APPLICATION COMPLETENESS MEMO

DATE: March 3, 2025

RE: #24-29 – Major Site Plan & Conditional Use – Camping World Expansion – 480 Roosevelt Trail – Sketch Plan Review – Camping World RV Sales, LLC

SUBSURFACE WASTEWATER DISPOSAL PLAN

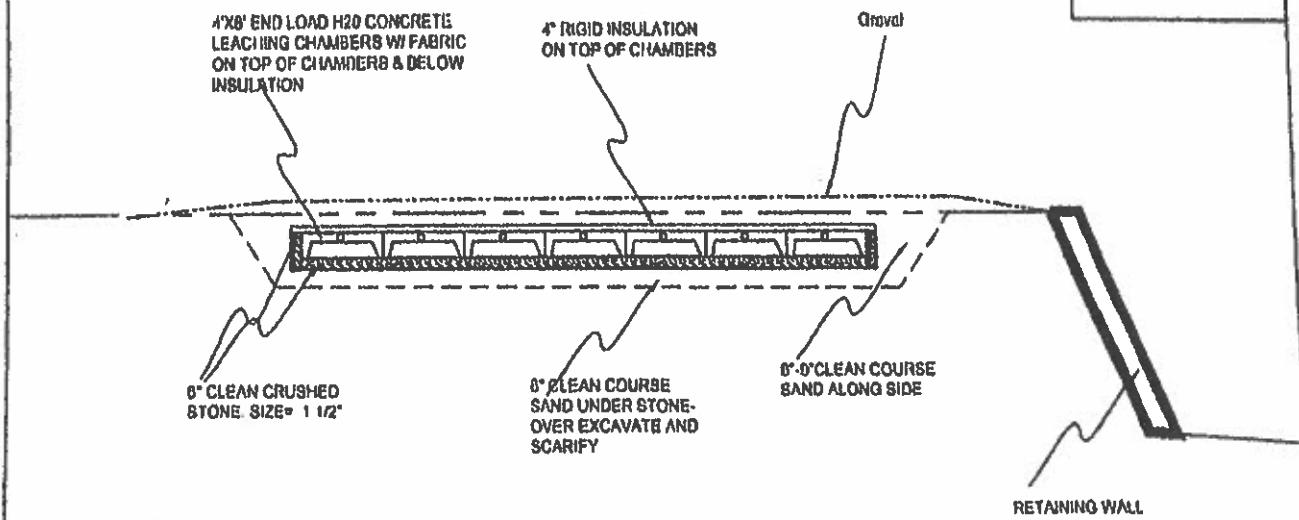
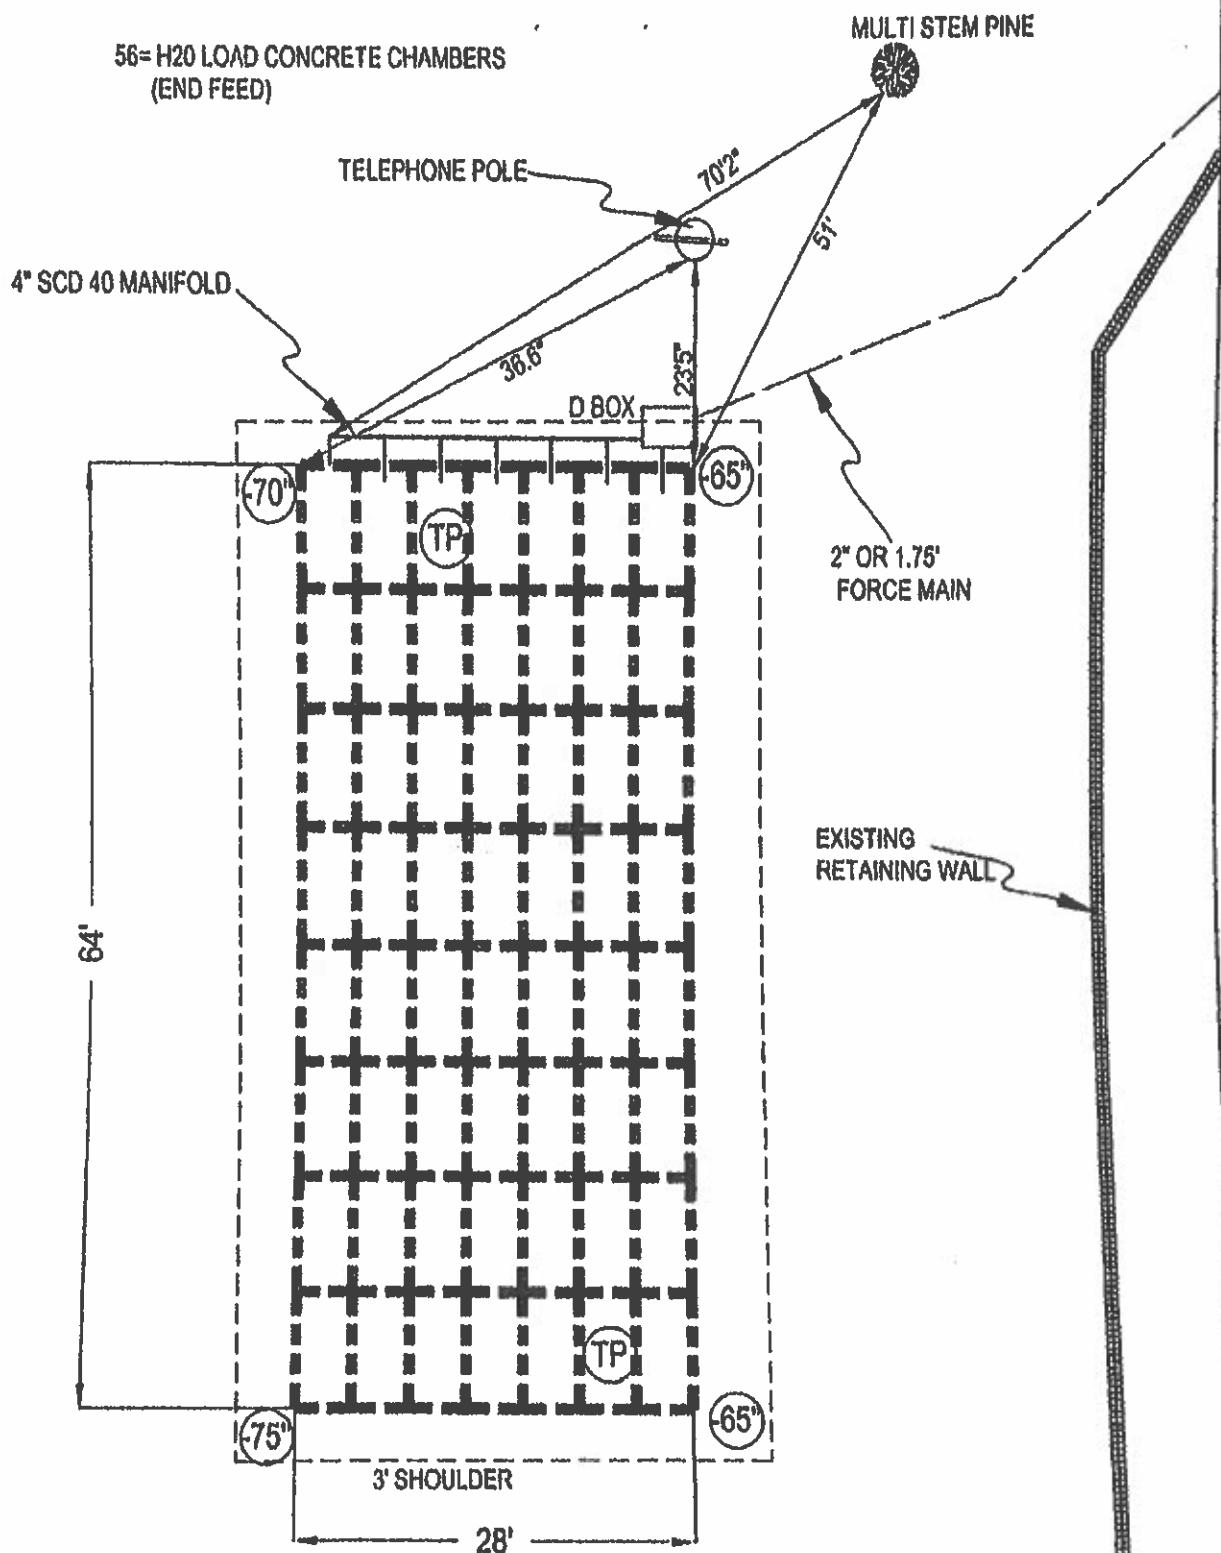
- **The Subsurface Wastewater Disposal System Application dated October 18, 2023, is inconsistent with the application submitted to the Code Department last year for the emergency repair permit. It is unacceptable that “10 dump stations x 5 = 500 gpd” was added to the design flow box without proper documentation. You must provide the correct application immediately. Furthermore, if a dump station is proposed, including design approval from the Department of Health and Human Services (DHHS) is imperative.**

The initial HHE-200 application dated 10-18-23 that included a “10 dump station X 5 for an additional 500 gallons per day was not approved. The recreational vehicle dump station(s) were removed by the applicant on 8-15-2024 and amended/ revised again to include a change in the disposal field elevations on 8-18-2024.

A new HHE-200 application would be required for the addition of a recreational vehicle dump station(s) and the designed system would need to meet first-time system criteria as per subsurface wastewater disposal. In addition, we would require additional information on the design flow (including an owner's statement) and any values greater than 2,000 gpd would require approval by the Department of Environmental Protection.
